Access Compliance Report

Public Rights-of-Way

(Curb Ramps)

Intersection ID: 28659	Main Street: HAMPTON_PLACE_DR	Cross Street: RIDGELINE_LN	Location:	N
ADA ID: F46C1F675C27	Ramp Type: PerpDiag	Initial Pass/Fail: Pass	Overall Compliance: No	Severity Score: 12.5
Codes/Mitigation Info/Possible Solution		Field Measurements/Component Compliance

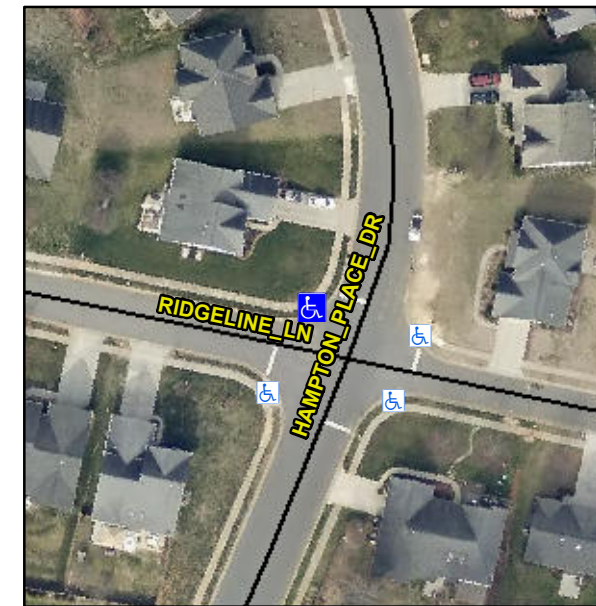
R304.2.1, R304.2.2-Perp, R304.3.2-Para, R304.2.3, R305.1.4, R302.7, R302.7.2

Compliance	Description	Data	Compliance	Description	Data
N/A	Ramp Length (in)	50.0	Yes	Ramp Slope (%)	5.1
Yes	Ramp Width (in)	55.5	Yes	Ramp XSlope (%)	1.4
N/A	Flare Type LT	Sloped	N/A	Flare Type RT	N/A
N/A	Flare Slope LT (%)	11.1	Yes	Flare Slope RT (%)	5.3
N/A	Flare Traversable LT?	Yes	N/A	Flare Traversable RT?	Yes
No	Landing Length (in)	45.0	Yes	DWS Provided?	Yes
Yes	Landing Width (in)	48.0	Yes	DWS Contrast?	Yes
No	Landing Slope (%)	4.6	Yes	DWS Length (in)	24.0
Yes	Landing X Slope (%)	0.6	No	DWS Full Width?	No
N/A	Landing Curb? (Y/N)	No	Yes	DWS Offset (in)	2.0
N/A	Shared Landing?	No			
No	Gutter Ponding?	Yes	Yes	Gutter Slope (%)	1.9
No	Gutter Lip Ht (in)	0.5	Yes	Gutter X Slope (%)	1.3
N/A	Painted X Walk1?	No	N/A	Painted X Walk2?	No
	X Walk 1 Direction	To SW		X Walk 2 Direction	To SE
N/A	X Walk 1 Width (in)	N/A	N/A	X Walk 2 Width (in)	N/A
	X Walk 1 Slope (%)	1.4		X Walk 2 Slope (%)	1.6
	X Walk 1 X Slope (%)	1.5		X Walk 2 X Slope (%)	0.4

N/A	Ramp inside XWalk1?	N/A	N/A	Ramp inside XWalk2?	N/A
	Road Slope (%)	1.6	N/A	Clear Space?	Yes
	Road X Slope (%)	1.9	N/A	Clear Space to XWalk (in)	N/A
Yes	Any Obstructions?	No	Yes	Storm Grate/Utility Hazard?	No
	Obstruction Type			Storm Grate/Utility Type	
		N/A			N/A
			Yes	Surface Condition? (G/P)	Good

Remove & Replace Curb Ramp With Two New Directional Ramps or Equivalent. Grind Gutter Lip.
